Delegated Report		Analysis sheet	Expiry Date:	03/06/2021
		N/A / attached	Consultation Expiry Date:	20/06/2021
Officer			Application Number(s)	
Obote Hope			2021/1691/P	
Application Address			Drawing Numbers	
Flat A 6 St Augustine's Road London NW1 9RN				
PO 3/4	Area Team Signature	C&UD	Authorised Officer Signature	
Proposal(s)				
Erection of rear dormer and a side dormer extension, installation of 2 x rooflights to the front roof pitch and 1 x rooflights to the side roof pitch all associated with the conversion of the loft space to provide additional residential accommodation.				
Recommendation(s):	Refused			
Application Type:	Full Planning Permission

1. Proposal

Image 2. Proposed roof plan

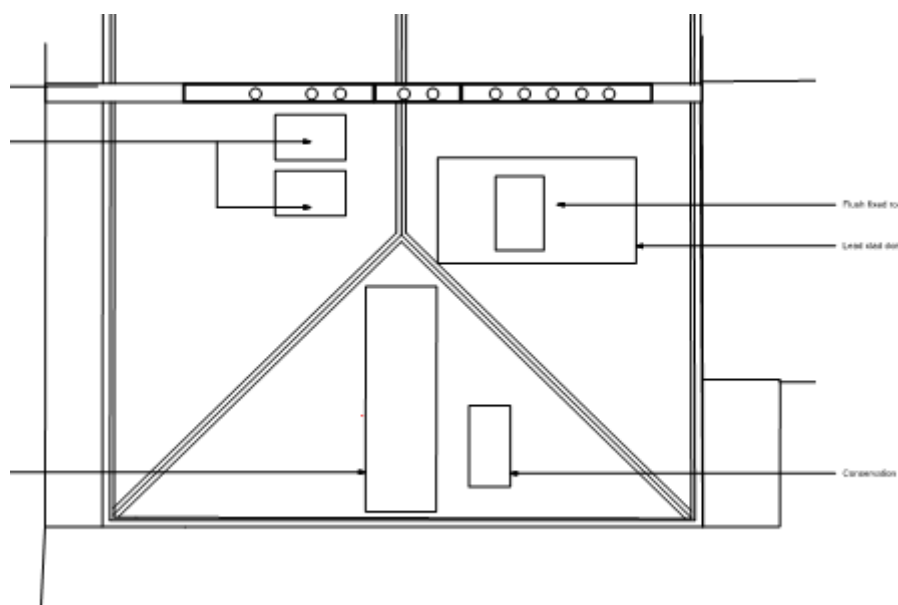
- 2.8 The proposed side dormer is not sympathetic to the host building and fails to respect its form and proportions. The proposed dormer would appear overbearing in terms of its height, form, scale and bulk relative to the scale of the host building. It would not appear as a modest 'dormer' sitting within the roofslope. The siting, design and appearance of the proposed dormer extension would be an inappropriate addition to the host building detracting from its character and appearance and the area in general. The dormer would be a discordant element, detracting from the roofscape and group value of the adjacent semi-detached properties.

Image 4. Proposed Rear

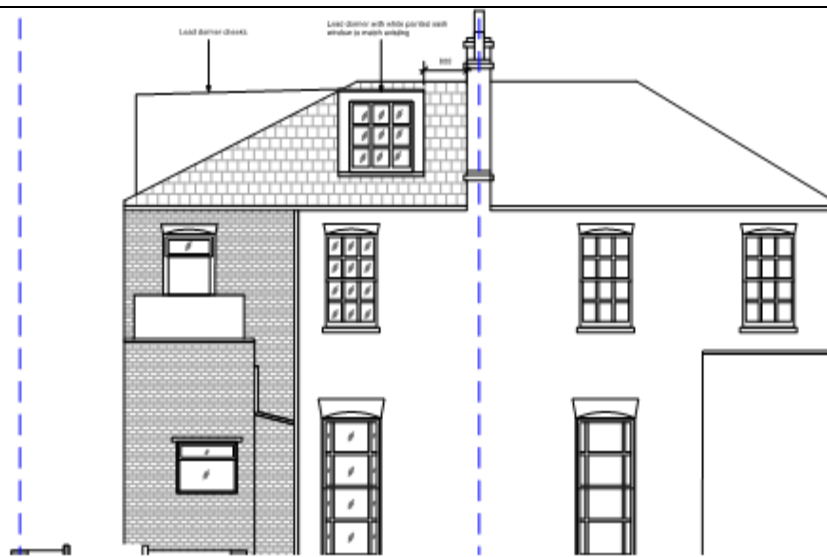
- 2.9. In terms of the rear dormer, it is noted that the rear elevations of these semi-detached villas in this part of St Augustine's Road (Nos. Nos. 6-52) display a remarkable degree of uniformity at roof level with no roof extensions. The unimpaired roof slopes contribute to the conservation area. In this context, the proposed dormer roof extension would diminish this uniformity and would appear as an incongruous addition harming the conservation. The side dormer would be particularly visible in public views and in private views from the properties on Argyle Grove.

- 2.10. The proposed rear dormer window would not relate well to the existing fenestration / rear elevation. The width of the proposed dormer (1.9m) would be significantly greater than the width of the windows on the lower floors (approx. 1.0m). The proposed dormer roof extension would fail to be subordinate and the combination of the side dormer with the proposed rooflights would have a cumulative impact on the host building and wider conservation area. This would result in the dormer roof extension appearing dominant within the shallow pitch of this roof slope. The shallowness of the roof slope is not appropriate for a dormer extension. The lack of visibility of the rear would not necessarily mitigate the harm to semi-detached pair and the wider Camden Square Conservation Area.

Image 5. Proposed Section BB

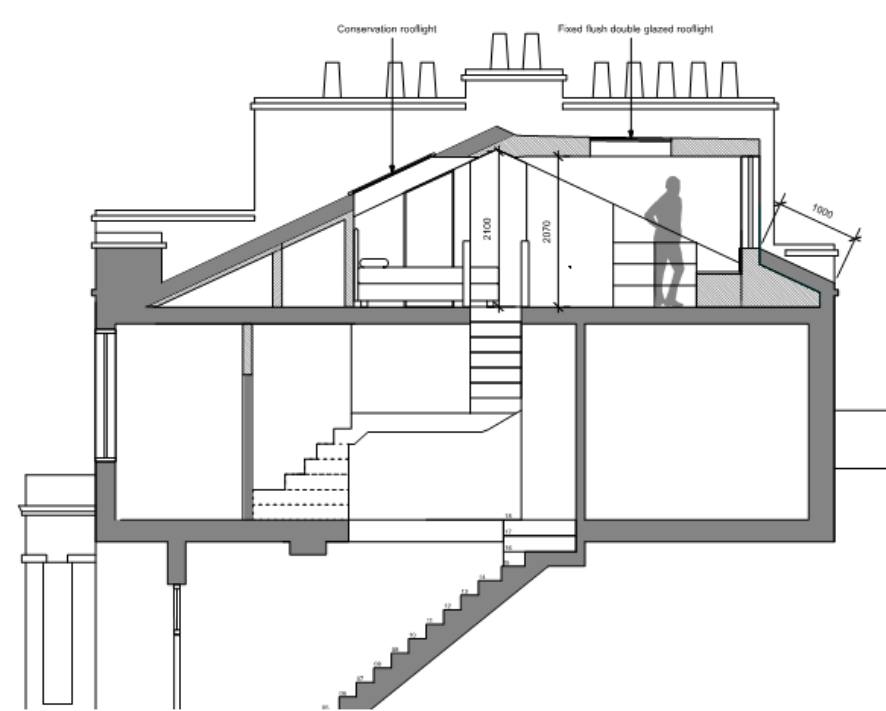
2.11 In addition, the internal alterations would allow the ceiling height to be 2.05m which is below the minimum 2.7m as recommended within the Governments Nationally Described Space Standards. It would provide compromised accommodation at third floor with a contrived layout. Adequate floor to ceiling height helps to ensure residential quality in terms of daylight penetration, ventilation and cooling, and sense of space. In this context, the proposed dormer extension would harm the appearance of the rear elevation and the skyline with questionable benefits in terms of the accommodation created. It is also noted that
